# Groundwater Application Review Summary Form

Application # LL- 1995

**A. GENERAL INFORMATION:** Applicant's Name: Domaine Serene Vineyard & Winery, Inc. County: Polk

A1. Applicant(s) seek(s) 0.045 cfs from 1 well(s) in the Willamette Basin,  
Middle Willamette subbasin

### Water-Level Measurements in Nearby Wells

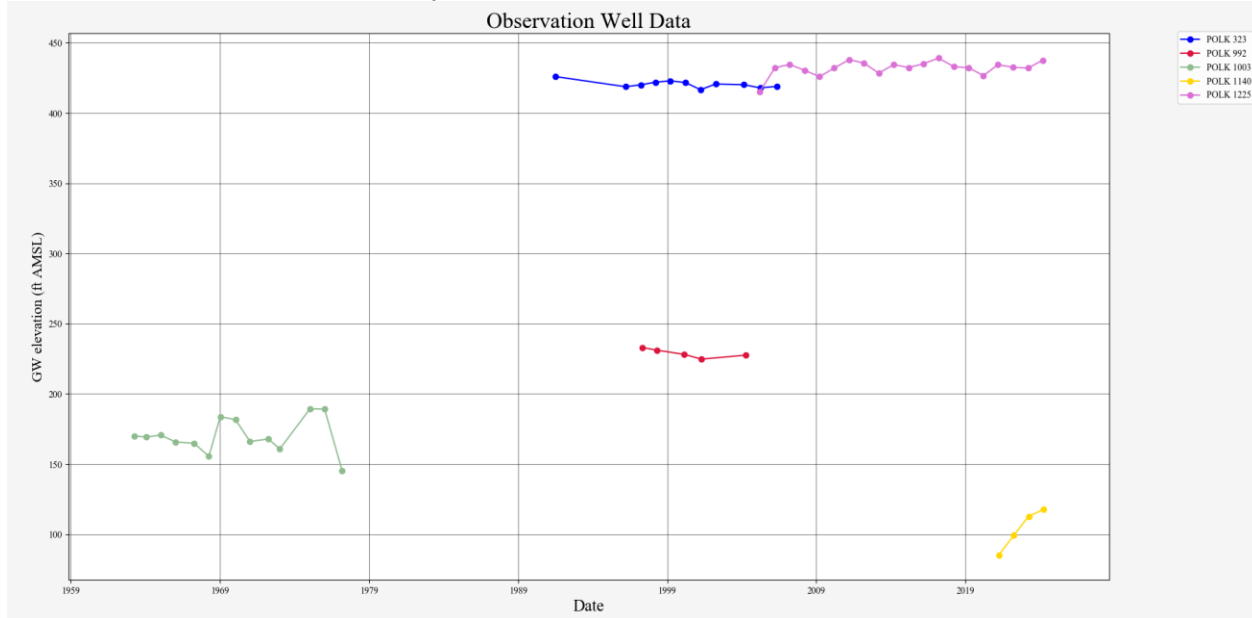
Water level trends for nearby (0 to 3 miles from POA) wells that utilize the CRBG are stable (see **Water Levels Measurements in Nearby Wells**). Although there have been notable declines in the past, the more recent data does not indicate these declines have continued. Within one mile of the POA, there are 6 PODs for 8 spring-sourced water rights and no groundwater rights. The relatively stable water level conditions and lack of groundwater use in the area suggests a low likelihood of over-appropriation. The groundwater resource is likely not over-appropriated.

### Theis Interference Analysis

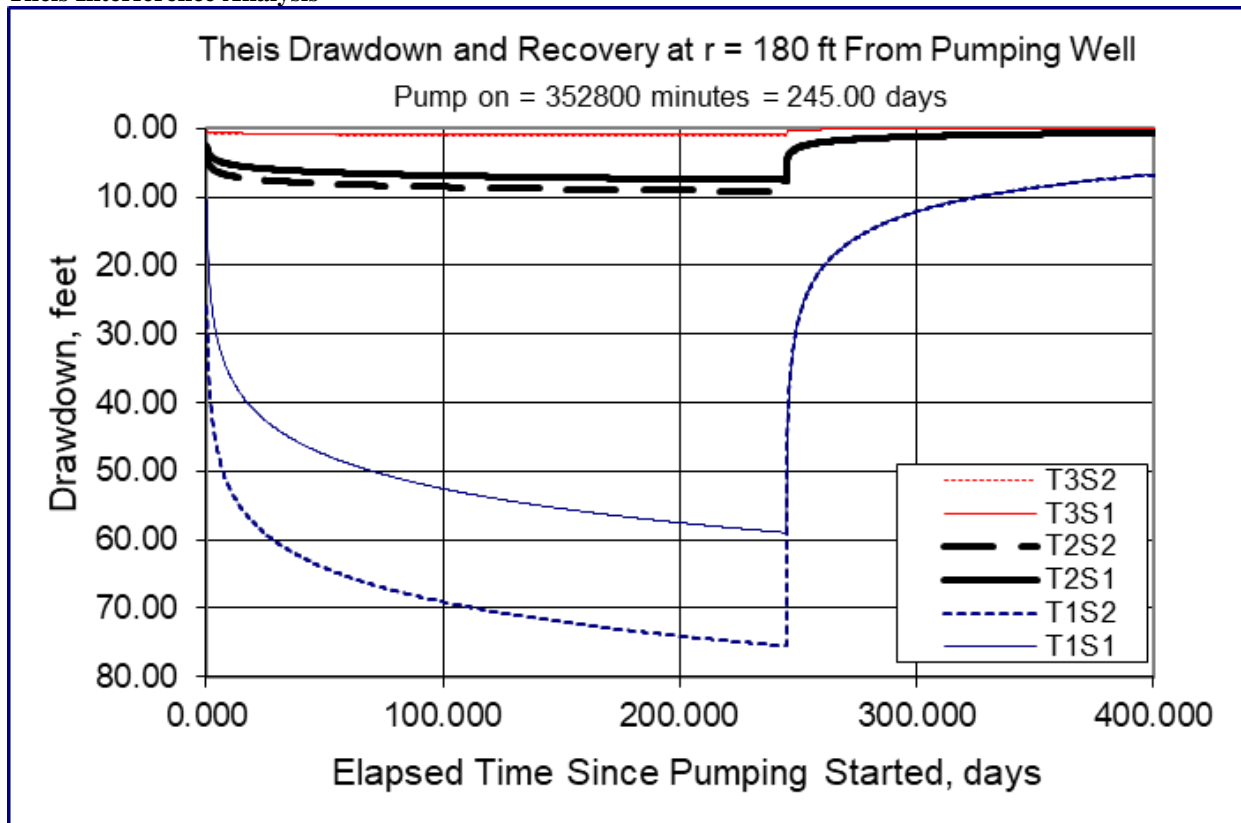
The nearest CRB groundwater user to the POA is likely the domestic well serving tax lot 701 at 3950 Bethel Heights Rd, located ~900 ft southwest of the POA, at an elevation of ~585 ft amsl. It is likely the proposed use would cause some degree of well-to-well interference with the well serving tax lot 701. To assess the degree of drawdown, a Theis drawdown analysis was conducted for the proposed use (see attached **Theis Drawdown Analysis-TL 701**). Results indicate that the proposed use **is not likely to cause well-to-well interference** with TL 701 that exceeds the threshold under the standard condition for basalt aquifers in the Willamette Basin.

Radial distance from pumping well ( $r$ )=180 ft [estimated radial distance to nearest groundwater user, tax lot 701]

**Pumping Rate ( $Q$ )= 0.023 cfs (~10.3 gpm)\***

Aquifer Transmissivity ( $T_1$ )= 165 gpd/ft (22 ft<sup>2</sup>/day), ( $T_2$ )= 1,646 gpd/ft (220 ft<sup>2</sup>/day), ( $T_3$ )= 16,456 gpd/ft (2,200 ft<sup>2</sup>/day)

Storativity ( $s_1$ ) = 0.0001, ( $s_2$ ) = 0.00001 [Conlon et al 2005, Table 1 values for Central CRB]

Total pumping time=245

\*The full pumping rate could not be utilized continuously for the entire 245-day period of use without exceeding the 11.15 ac-ft maximum allowed duty. For the maximum allowed duty of 11.15 ac-ft, continuous pumping would occur for 245 days at a rate of 0.023 cfs (~10.3 gpm).
